CITY OF ALBUQUERQUE

Re: The Carlisle Condominiums
3600 Central Ave SE
Request Permanent C.O. - Accepted
Engineer's Stamp dated: 9-16-15 (K17D069)
Certification dated: 3-19-18

CARLISLE CONDOMINIUMS

GRADING & DRAINAGE PLAN

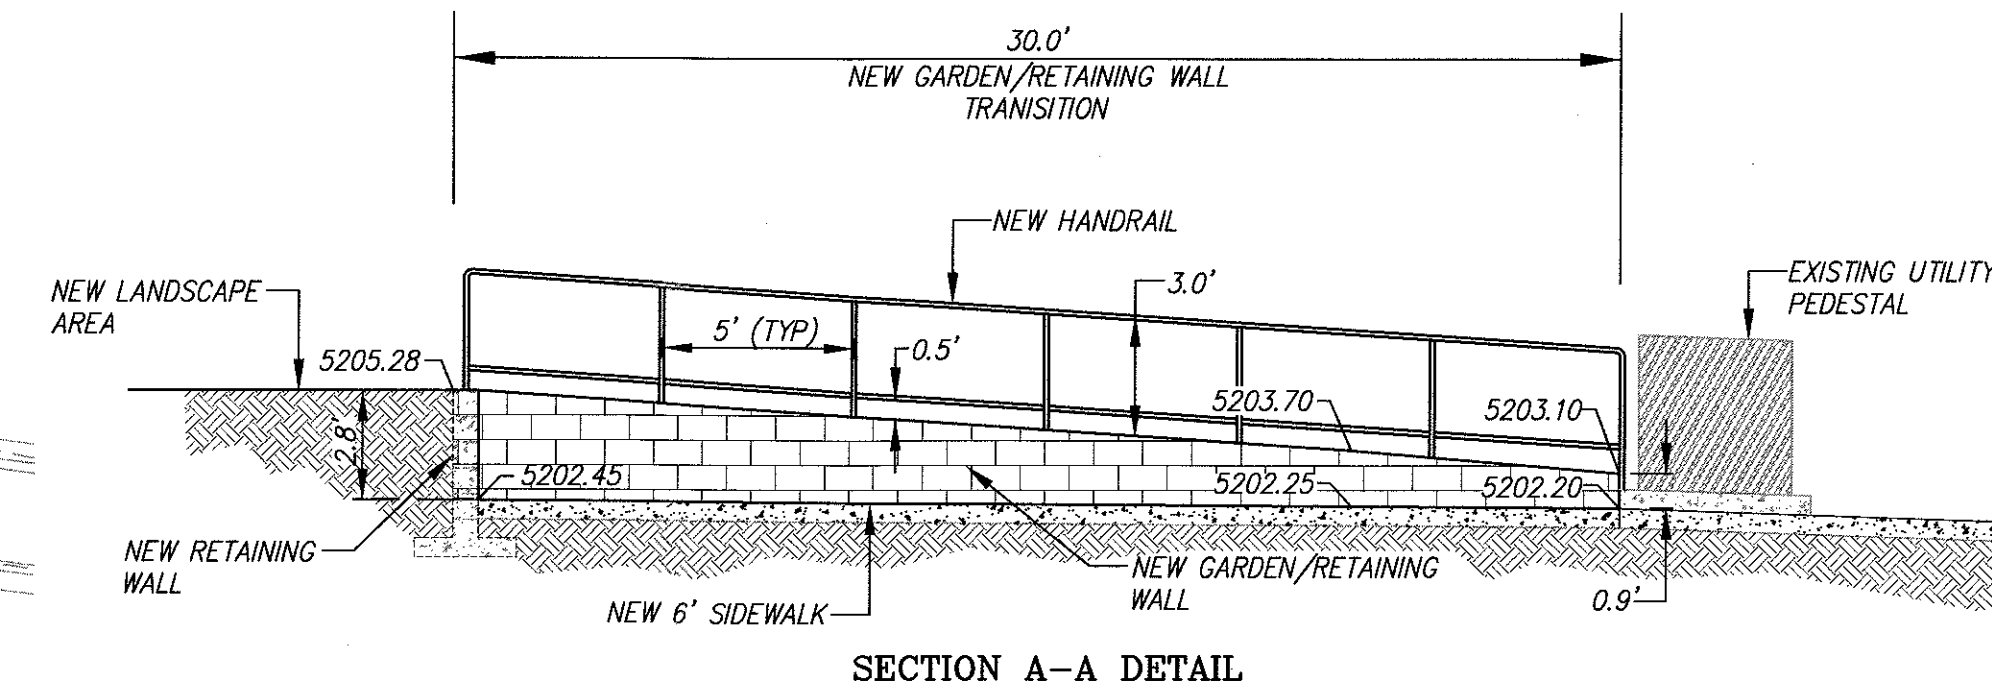
Based on the Certification received 3/19/2018, the above mentioned business is acceptable for release of Certificate of Occupancy by Hydrology.
